Errata for the Compute Express Link™ (CXL™) Specification Revision 1.1

October 2019

Revision	Description	Date
1.0	First Release: Errata E1-E16.	October 2019

Figure 45. H0 - H2D Req + H2D Resp

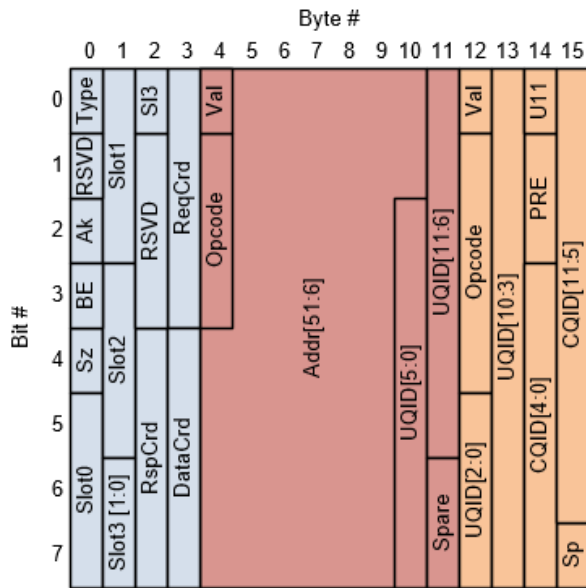
In Section 4.2.3, following diagrams for Header Slot Formats need to be updated to show Slot 3 bit encodings in correct bit positions. Also fixed Figure 50, which showed Addr[51:6] in CXL1.1, but should have show Addr[51:5] to match address bits required for M2S Req.

Figure 39. Write from Host

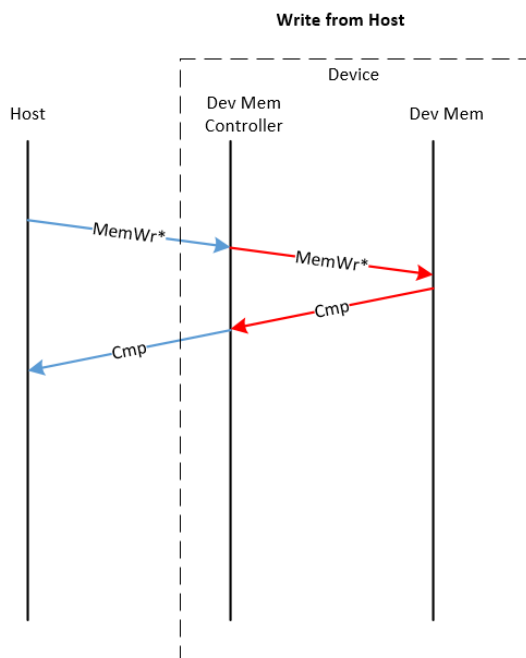
Update Figure 39, Red arrows from Device Memory Controller to Device Memory should be MemWr* and Cmp

Figure 70. G5 - ~~3~~₂ S2M NDR

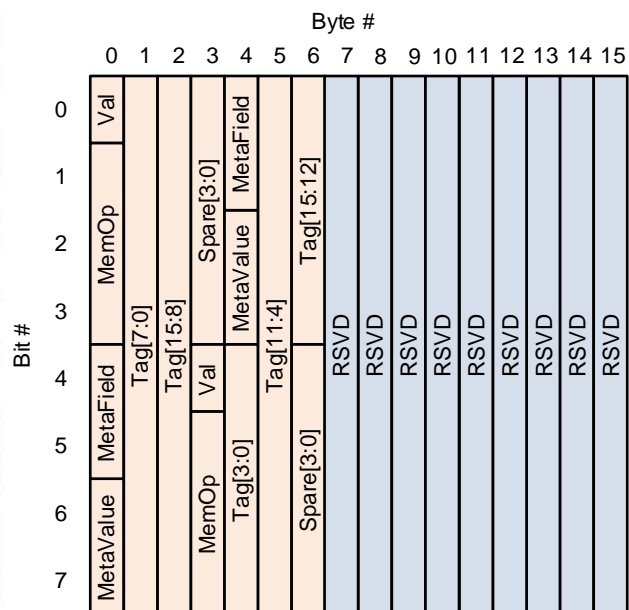
Updates to S2M/D2H G5 format from 3 NDR to 2 NDR messages. The global flit rules in section 4.2.5 restrict total S2M NDR to 2 total per flit which take precedence, so it is impossible to make use of 3rd NDR message in the S2M/D2H G5 format. Changing the G5 format to only include 2 NDR is done to ensure consistency and avoid confusion.

First change is to Table 40. Second change is to change G5 format in Figure 70 to include only the first 2 NDR messages converting the 3rd to RSVD bits.
